FEATURE UPDATE | JULY 2021

Version 212 (6/28/21) Update

Starting July 1, 2021, all X1 Series Door Controllers can update to Version 212 (6/28/21) firmware.

Initialize Hardware at Door Controller

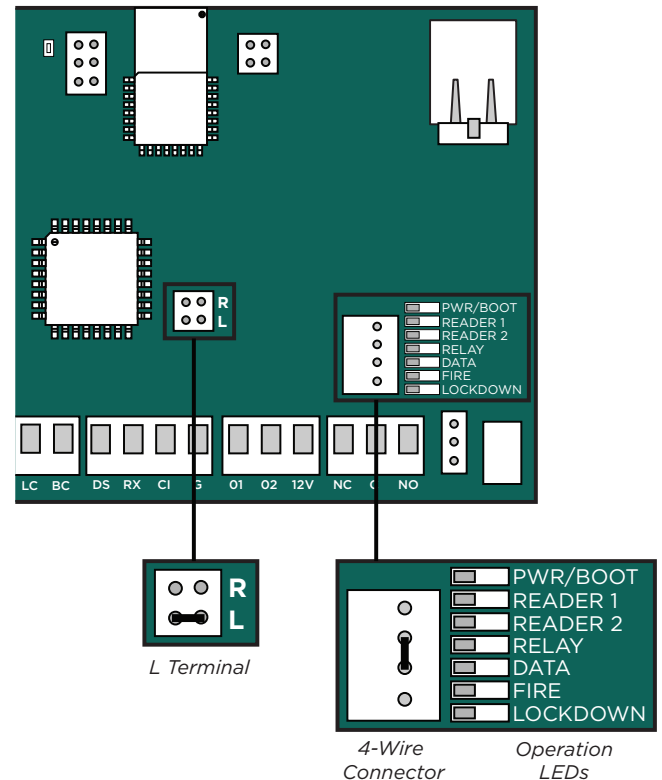
With Version 212 (6/28/21) the X1 can now be set to factory settings locally at the door controller without a required connection to Dealer Admin™.

To initialize the door controller, perform the following steps:

1. *X1-8 Only:* Unplug the XD door control module(s) from the 4-wire connector.
2. Place a jumper over the L header of the door controller.
3. Within 15 seconds, place a jumper on the center two pins of the 4-wire connector (short the green and yellow together). Reader 1, Reader 2, Fire, and Lockdown operation LEDs will turn on.
4. Within 15 seconds, remove both jumpers. The above LEDs will turn off. The Power LED will turn on steady to indicate the factory default is complete.
5. *X1-8 Only:* Plug the XD door control module(s) back into the 4-wire connector.

This process clears all Dealer Admin programming and defaults the system back to factory settings.
